# Access Compliance Report

## Public Rights-of-Way

Intersection ID: 7368	Main Street: BURCH_DR	Cross Street: DISTRIBUTION_CENTER_DR	Location: SW
ADA ID: 8934E65FE3C0	Ramp Type: Perp	Initial Pass/Fail: Fail	Overall Compliance: No
Severity Score: 37.5			
Codes/Mitigation Info/Possible Solution		Field Measurements/Component Compliance

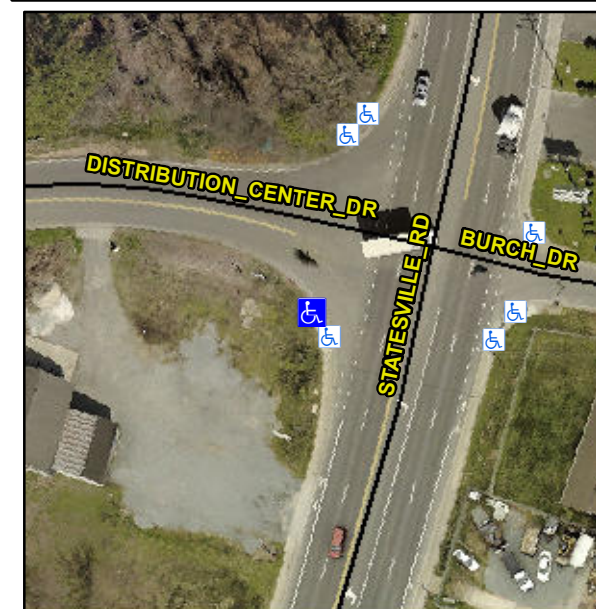
**Not Found, R304.5.1, R304.2.2, R304.5.3, R302.7**

Compliance	Description	Data	Compliance	Description	Data
N/A	Ramp Length (in)	61.0	No	Ramp Slope (%)	8.5
No	Ramp Width (in)	44.0	No	Ramp XSlope (%)	4.0
N/A	Flare Type LT	N/A	N/A	Flare Type RT	N/A
N/A	Flare Slope LT (%)	N/A	N/A	Flare Slope RT (%)	N/A
N/A	Flare Traversable LT?	N/A	N/A	Flare Traversable RT?	N/A
N/A	Landing Length (in)	N/A	N/A	DWS Provided?	N/A
N/A	Landing Width (in)	N/A	N/A	DWS Contrast?	N/A
N/A	Landing Slope (%)	N/A	N/A	DWS Length (in)	N/A
N/A	Landing X Slope (%)	N/A	N/A	DWS Full Width?	N/A
N/A	Landing Curb? (Y/N)	N/A	N/A	DWS Offset (in)	N/A
N/A	Shared Landing?	N/A			
N/A	Gutter Ponding?	N/A	N/A	Gutter Slope (%)	N/A
N/A	Gutter Lip Ht (in)	1.0	N/A	Gutter X Slope (%)	N/A
N/A	Painted X Walk1?	No	N/A	Painted X Walk2?	N/A
	X Walk 1 Direction	To NE		X Walk 2 Direction	N/A
N/A	X Walk 1 Width (in)	N/A	N/A	X Walk 2 Width (in)	N/A
	X Walk 1 Slope (%)	0.9		X Walk 2 Slope (%)	N/A
	X Walk 1 X Slope (%)	3.6		X Walk 2 X Slope (%)	N/A

N/A	Ramp inside XWalk1?	N/A	N/A	Ramp inside XWalk2?	N/A
	Road Slope (%)	N/A	N/A	Clear Space?	N/A
	Road X Slope (%)	N/A	N/A	Clear Space to XWalk (in)	N/A
N/A	Any Obstructions?	N/A	N/A	Storm Grate/Utility Hazard?	N/A
	Obstruction Type			Storm Grate/Utility Type	
		N/A			N/A
		No		Surface Condition? (G/P)	Poor

**Remove & Replace Entire Ramp.**
